SERVICE BULLETIN NO. 135

”ER4” (high-temperature circuit breaking)

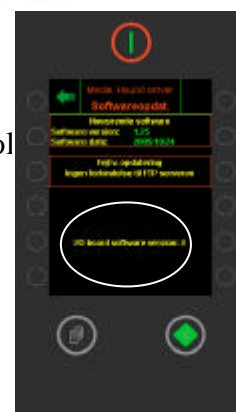
The current IO board version can also be read from the control:

On the turn-switch control, in the minute display after start-up (2-5).
